INVITATION FOR BIDS
CCK-2563.30-7-25
CTC + AAC BP07 Core & Shell Group 2
Project# 2563.30
ADDENDUM #2
09/12/2024

Addendum #02

Client	University of Kentucky Healthcare	Date	09/11/2024
Project	UK CTC BP-07 Core and Shell Group 2	UK Project #	2563.0
		Champlin Project #	514-5350

SHEET NO.
A202.C

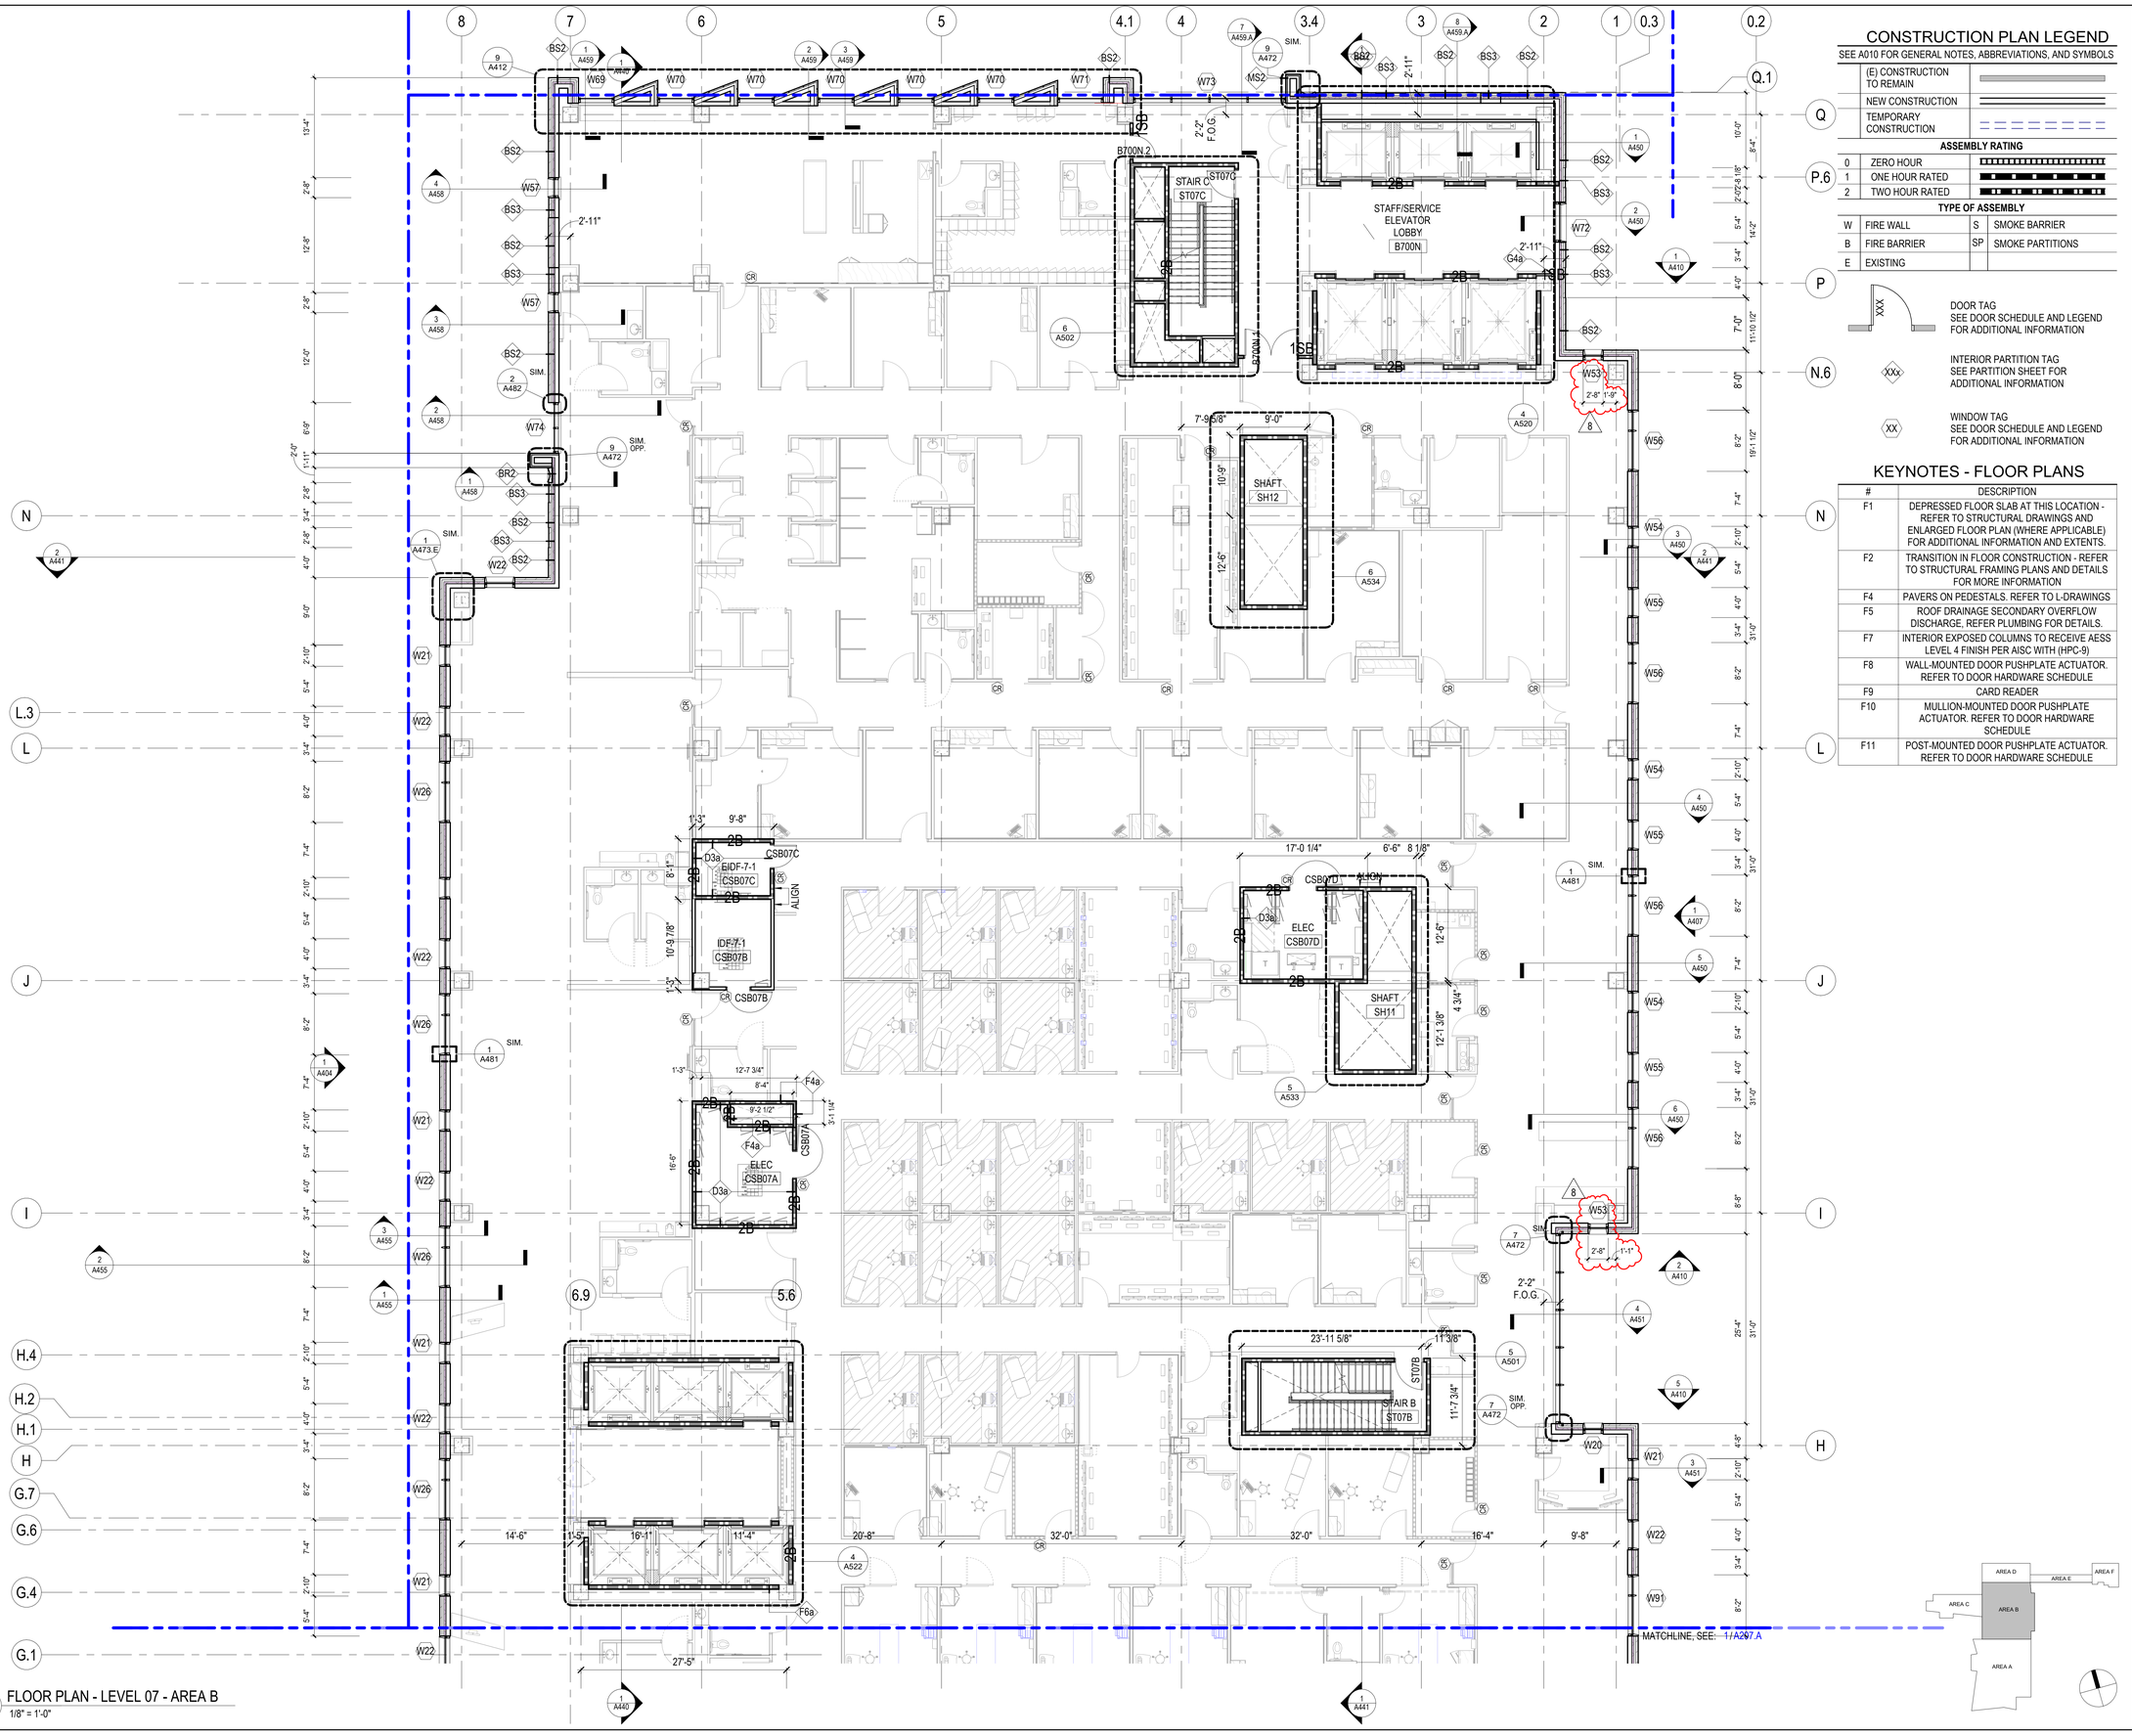
A202.C-SHELL & CORE FLOOR PLAN - LEVEL 02 - AREA C

1. *Revise curtain wall elevation tags.*

SHEET NO.
A207.B

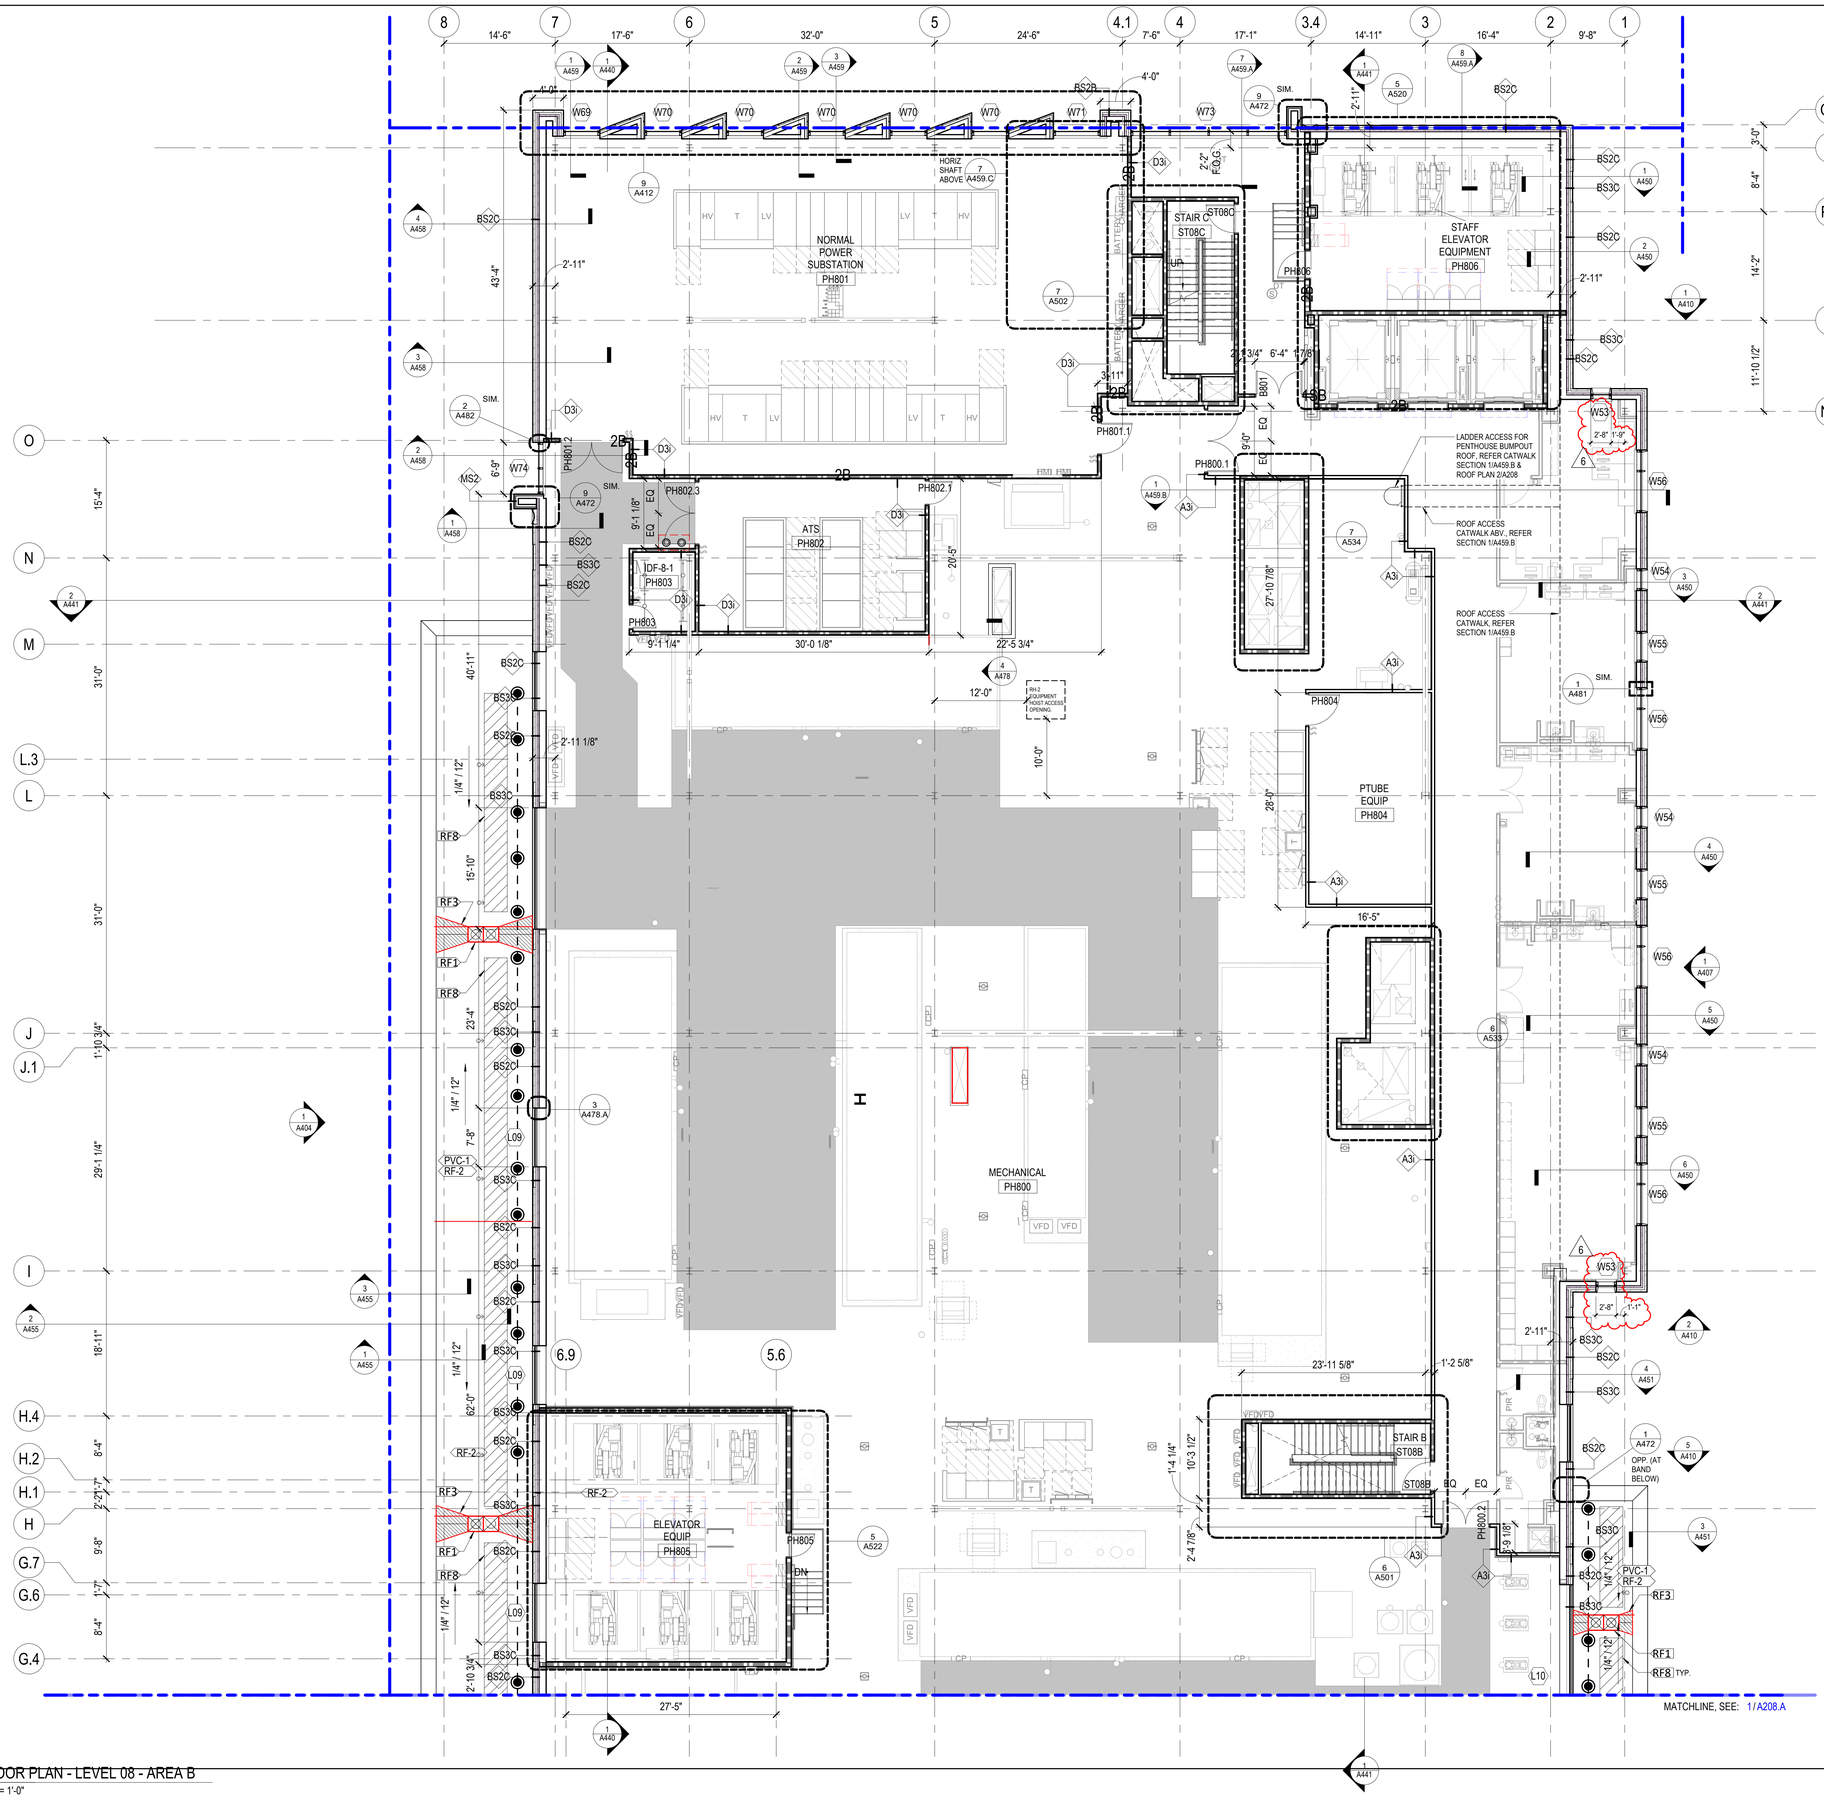
A207.B-SHELL & CORE FLOOR PLAN - LEVEL 07 - AREA B

1. *Revise curtain wall elevation tags*

SHEET NO.
A208.B

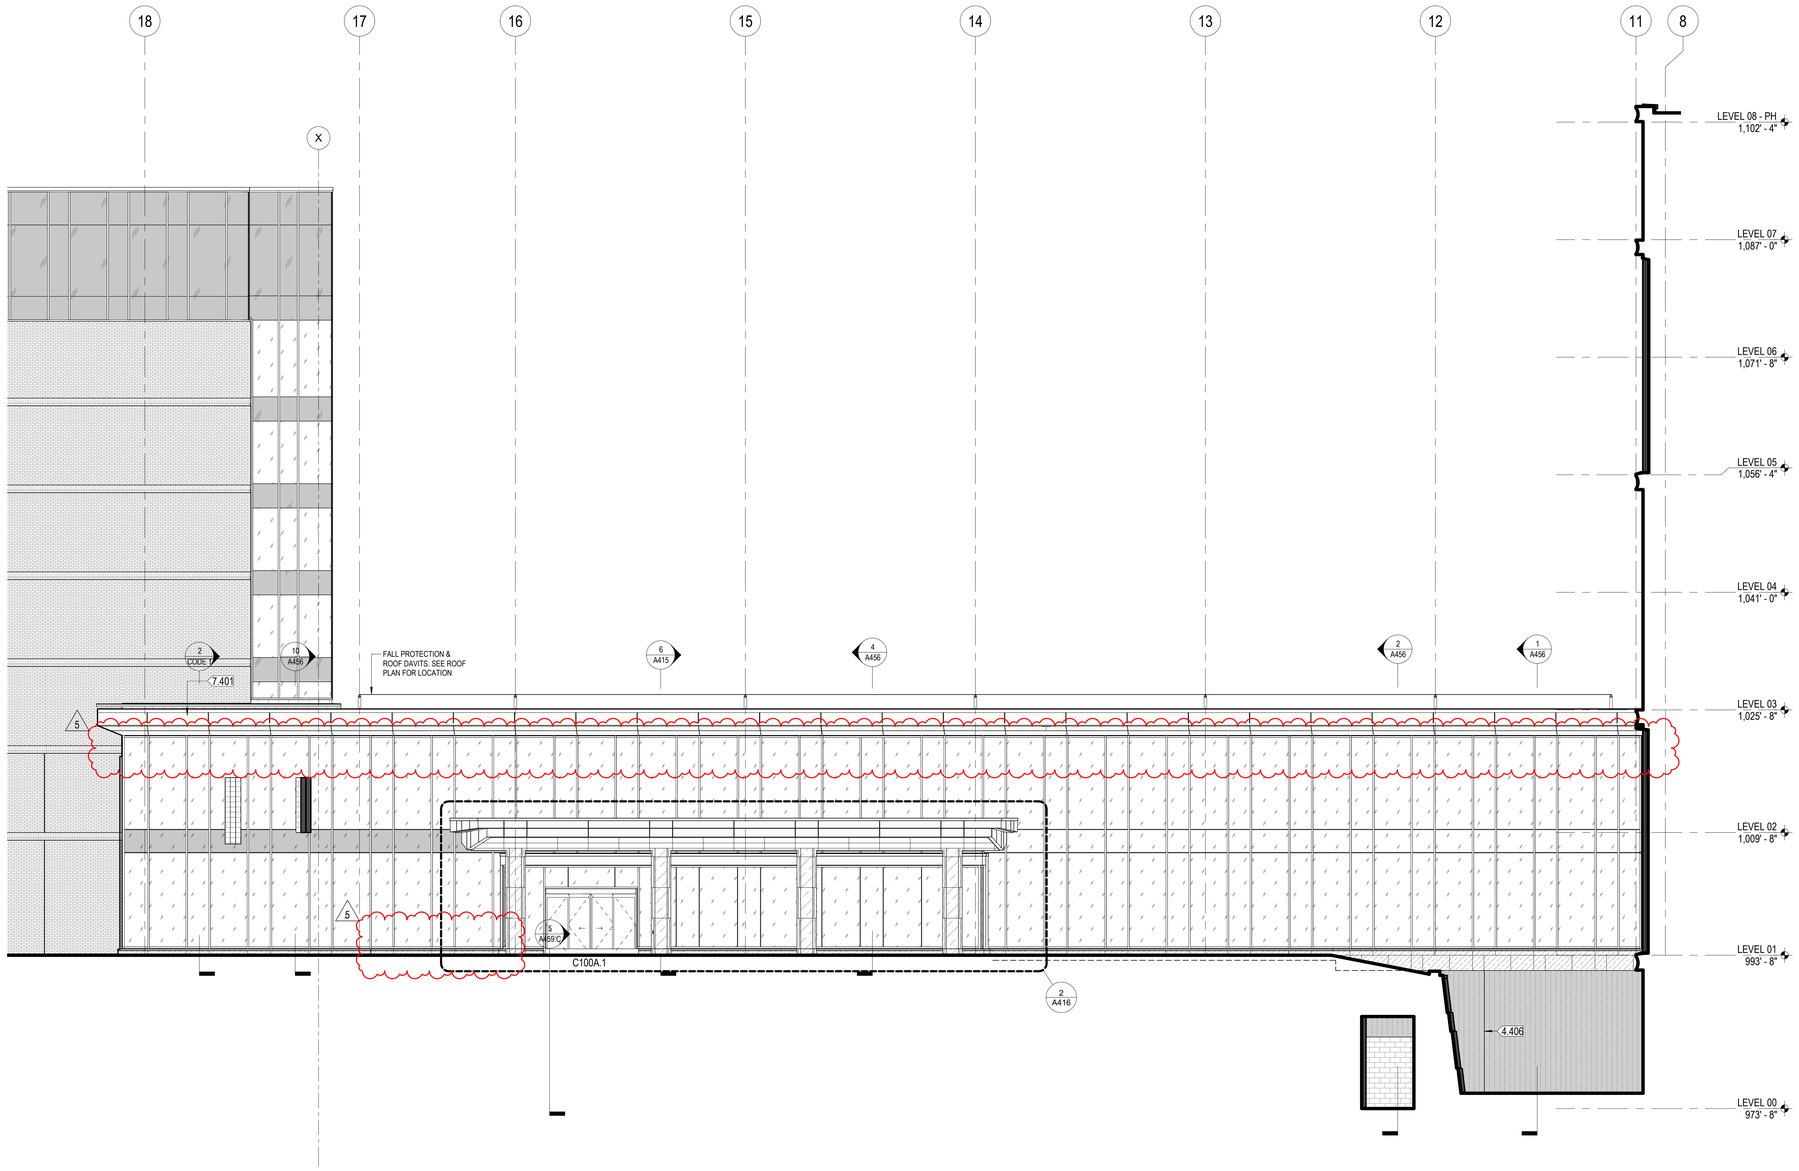
A208.B-SHELL & CORE FLOOR PLAN - LEVEL 08 - AREA B

1. *Revise curtain wall elevation tags.*

5 PLAN DETAIL - ROOF ACCESS DOOR IN LOUVER
1 1/2" = 1'-0"

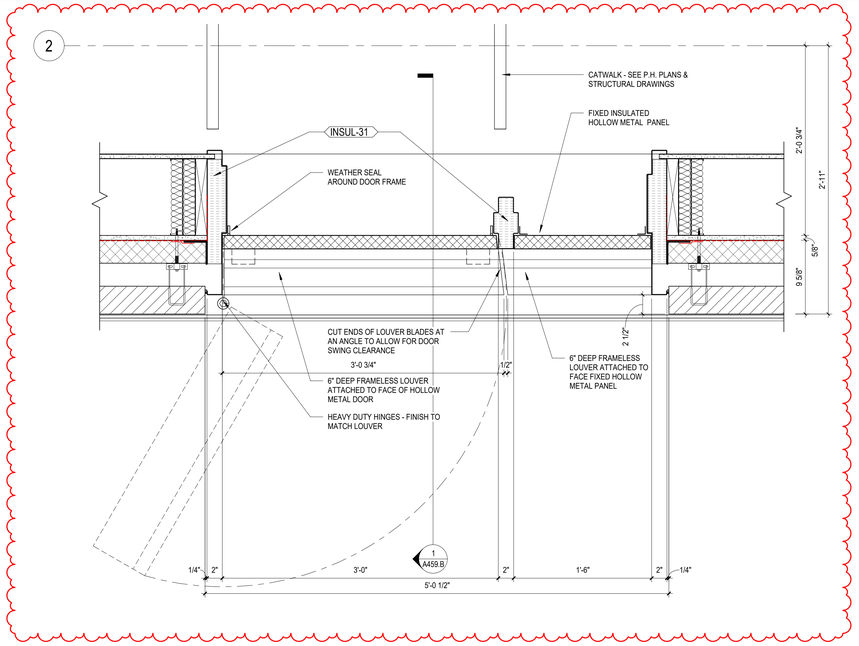
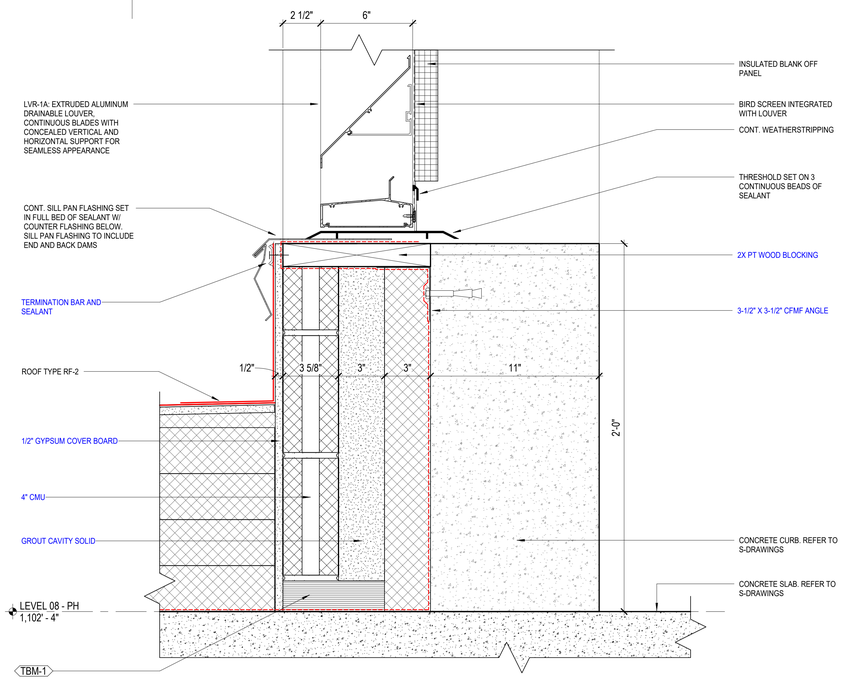
1. *Added Louver door elevation and plan detail of roof access louver.*
